The Open Space Committee, at our last meeting on December 6<sup>th</sup>, took under consideration the proposed project “Washington Street Homes”. Based on the limited documentation on the development proposal now posted on the Town website, the committee does have concerns regarding how close the project physical elements are sited to the existing 10-ft width Bailey Trail Extension easement.

**RE:** **Comments on Washington Street Sherborn Homes affordable housing project**

**Sherborn Groundwater Protection Committee - Comments to the Select Board on the proposed Washington Street Homes 40B Development.**

RE: Chapter 40B Comprehensive Permit for Washington Street Sherborn

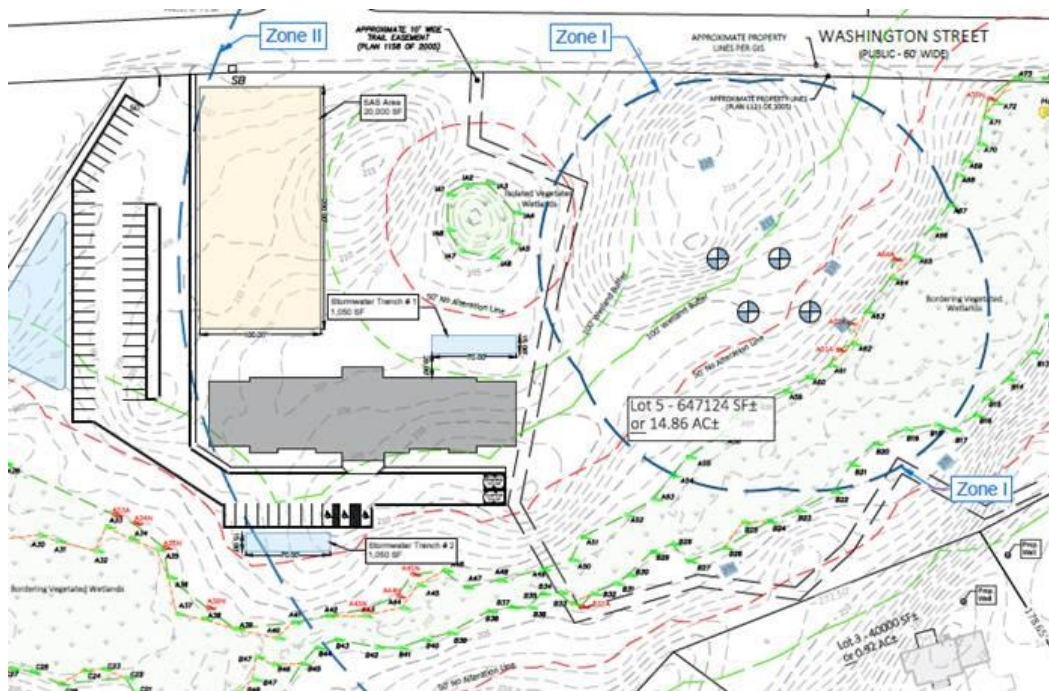
As seen by a portion of the proposed site plan inserted here, the 3-story building and paved parking area are within a few feet of the trail, and stormwater trench # 1 is also nearby. This trail brings many current residents from the areas of Greenwood St, Russet Hill Road, Washington Street, Woodland Road, and additional neighborhoods through this currently undeveloped forested wetland property. Walkers and bike riders traverse this short trail in order to get to the longer Bailey Trail, which has a trail head at the intersection of Washington St (Rt 16) and Old Orchard Road. The addition of the 40 apartment units (70 bedrooms) will increase trail use considerably.

The siting of the 3-story building and associated construction period disruption in all directions surrounding the building will impact the use and enjoyment of this trail during and after construction. To mitigate these issues can we suggest the developer consider:

Working with the easement title holder, the Conservation Commission, to move the trail easement some distance to the east, away from the proposed building and parking lot. The extensive wetlands on the site may complicate this, but perhaps the small trail bridging across the wetlands can be maintained, and the trail moved eastward after that section.

1. Working with the easement title holder, the Conservation Commission, to move the trail easement some distance to the east, away from the proposed building and parking lot. The extensive wetlands on the site may complicate this, but perhaps the small trail bridging across the wetlands can be maintained, and the trail moved eastward after that section.
2. Install a cross walk with yellow safety lighting across the busy state Route 16, to a safe spot near the main Bailey Trail (Old Orchard Rd trail head) to protect the pedestrians and bikers as they cross this busy road.
